S A V A N N A H   H I S T O R I C   D I S T R I C T  
B O A R D   O F   R E V I E W

**REQUEST FOR CERTIFICATE OF APPROPRIATENESS**

**Petitioner:** Scott Cook  
**MPC File No.:** 24-006552-COA  
**Address:** 21 West Bay Street  
**PIN:** 20004 14006  
**Zoning:** D-CBD  
**Staff Reviewer:** Kelli Mitchell  
**Date:** January 8, 2025

The applicant is requesting approval to carry out alteration and rehabilitation work on 21 West Bay Street.

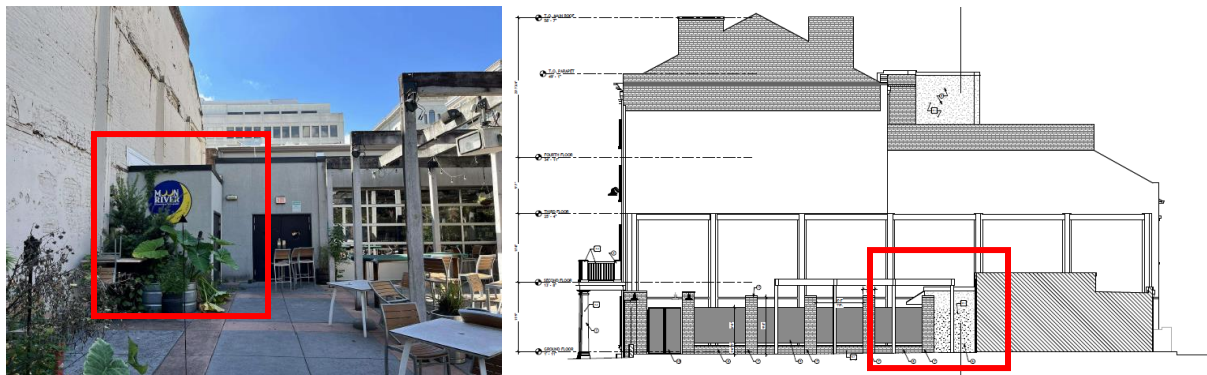
\*TPO is neither an approved nor denied material. This material has been approved on flats roof in this district, however.

Staff finds that the proposed materials, as presented, meet the standards.

The proposed colors are laid out in the plans. While staff finds that the majority of the proposed colors to meet the standards, staff has concerns about the use of a silver color for the stucco on the elevator/lobby addition. This is not a common color for stucco in the area. Staff finds that another more traditional color should be used.

- 1. Select a more visually compatible color for the stucco.**
- 2. Receive an encroachment permit from the City of Savannah for the front porch.**
